Docket Number:	23-AFC-01
Project Title:	Morton Bay Geothermal Project (MBGP)
TN #:	252809
Document Title:	Morton Bay Geothermal Project Data Request Response Set 2
Description:	N/A
Filer:	Jerry Salamy
Organization:	Jacobs
Submitter Role:	Applicant Consultant
Submission Date:	10/27/2023 3:29:24 PM
Docketed Date:	10/27/2023

Data Response Set 2 (Responses to Data Requests 1 to 10)

**Morton Bay Geothermal Project
(23-AFC-01)
October 27, 2023**

Figure DRR 9a-1
 Salton Trough Tectonic Map,
 Morton Bay Geothermal Project
 Imperial County, California

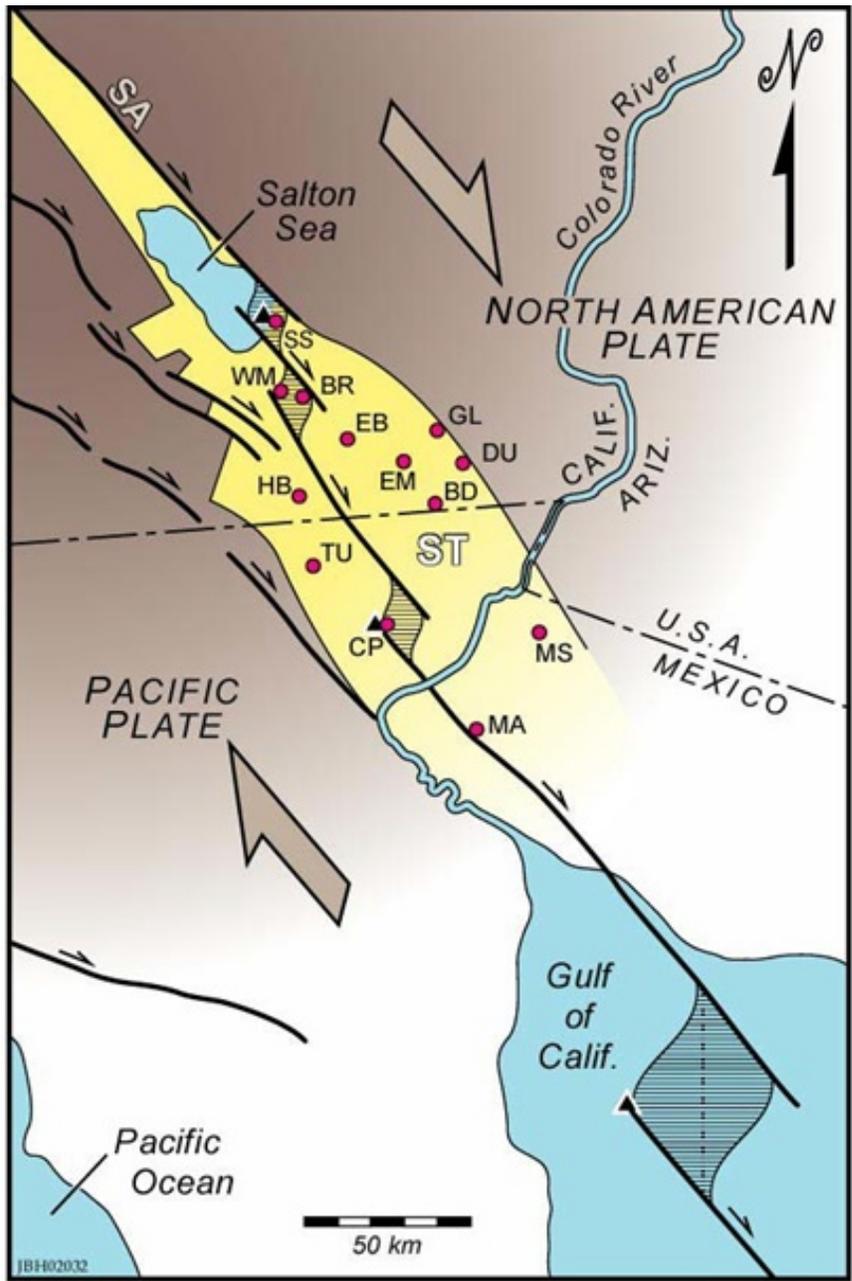
9. To allow environmental review of the potential impacts of the whole of the project, please provide preliminary information used for planning injection well installation, as follows.
 - a. Known properties of the injection reservoir

Geology

The Salton Sea geothermal reservoir occurs in fractured sedimentary rocks within the Salton Trough, a structural depression on the boundary between two tectonic plates. The northwest motion of the Pacific Plate on the west, relative to the North American Plate on the east, has created regional right-lateral faults striking NW-SE and local conjugate left-lateral faults striking NE-SW, shown as Figure 1 in the report titled "Geology and a Working Conceptual Model of the Obsidian Butte (Unit 6) Sector of the Salton Sea Geothermal Field (Hulen et al., 2003²). A copy of this figure is provided as Figure DRR 9a-1. The Salton Trough began its existence in Oligocene to Miocene time as a coaxial but smaller and shallower proto-rift, developed as a Basin and Range-style back-arc basin in response to subduction of the Farallon plate beneath the North American plate. Oligocene to Miocene basalts along the margins of the modern Trough attest to the lithospheric thinning, heating, and mafic-alkaline magmatism that accompanied the older rifting episode. The nature of the basement in the Trough remains conjectural. Gravity and seismic data suggest that low-density (2.3-2.55 g/cm³) sediments rest upon an intermediate-density (2.65 g/cm³) basement extending to about 39,000 feet depth. The intermediate basement, in turn, overlies a higher density (3.1 g/cm³) layer extending to the base of the crust at about 77,000 feet. This deep layer is inferred to be gabbro, added to the crust to compensate isostatically for the low-density sediments supplied from above (Hulen et al., 2002).

Heat sources for the high-temperature geothermal systems of the Salton Trough have traditionally been envisioned as gabbroic. The Salton Trough is filled to a depth of approximately four (4) miles with Colorado River sediments, interbedded with salt deposits from periods of lake evaporation. Within the Salton Sea field, past volcanic activity is indicated by five outcrops of rhyolite - Obsidian Butte, Rock Hill, Red Island (North and South), and Mullet Island) - as well as extrusive and shallow intrusive igneous rocks encountered in several wells.
